UNITED STATES PATENT AND TRADEMARK OFFICE

09/471,981

Office Action Summary

DETAILED ACTION

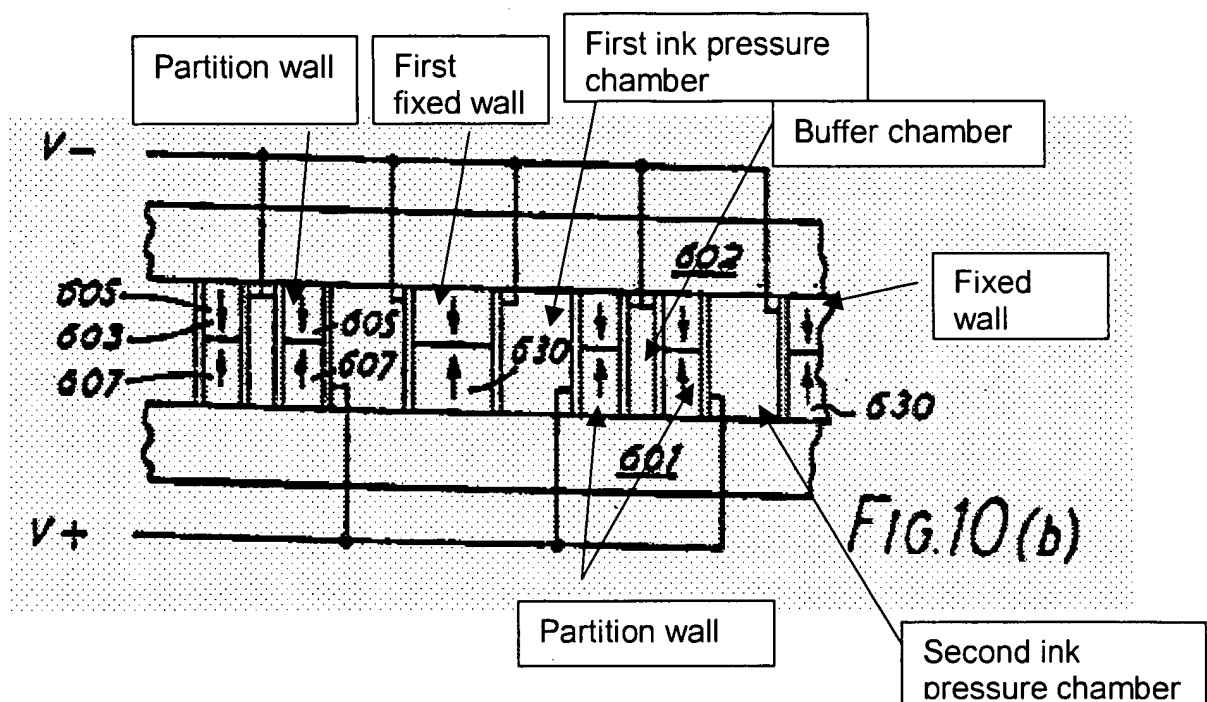
1. Claims 3, 39, 42, 44-50, 58, 61-63, 71, 76 and 81-82 are rejected under 35 U.S.C. 103(a) as being unpatentable over Bartky et al. (USPN 5,003,679) in view of Takuchi et al. (USPN 5,592,042).

- an ink-jet recording head comprising at least one piezoelectric block (Fig.10b);
- Each piezoelectric block (B) has first and second ink pressure chambers (Fig.10b);
- each pressure chamber communicating with a nozzle, first and second partition walls (Fig.10b);
- each partition wall serving as a driving portion for one of the ink pressure chambers, each partition wall including a piezoelectric element and two electrodes (Fig.10b) for driving said piezoelectric element;
- a pressure buffer chamber and first and second fixed walls (Fig.10b);
- The first fixed wall, the first ink pressure chamber, the first partition wall, the pressure buffer chamber, the second partition wall, the second ink

pressure chamber, and the second fixed wall are arranged in sequence along a thickness direction (Fig.10b) and surface of the electrodes are oriented perpendicular to the thickness direction, the driving portion is polarized in the thickness direction and perpendicular to the surfaces of the electrodes (Fig.10b), at least one electrode for controlling, by bending of the electrode, whether the partition wall bend toward a side of the ink pressure chamber or bends towards a side of the pressure buffer

- a plurality of these blocks, arranged in the thickness direction.
- the pressure buffer chambers are all closed on a side at which the nozzle communicating with the ink pressure chamber is open (Fig.10b).
- there are two electrodes per partition wall, one of which is exposed to the pressure buffer and the other exposed to the ink pressure chamber;
- a portion at which the electrodes on a partition wall face each other is included in a portion at which the ink pressure chamber and pressure buffer chamber face each other (Fig.10b);
- the piezoelectric block is an integrally sintered one piece block structure;
- the distance between nozzles appears to be constant (Fig.10b).

However, Bartky fails to teach at least one of the electrodes is embedded in the wall;

Takuchi et al. show that the electrode is between the piezoelectric portion and embedded in the piezoelectric portion is an equivalent structure known in the art. Therefore, because the electrode is between the piezoelectric portion and embedded in the piezoelectric portion were art recognized equivalents at the time the invention was made, one of ordinary skill in the art would have found it obvious to substitute the electrode is embedded for electrode is in between.
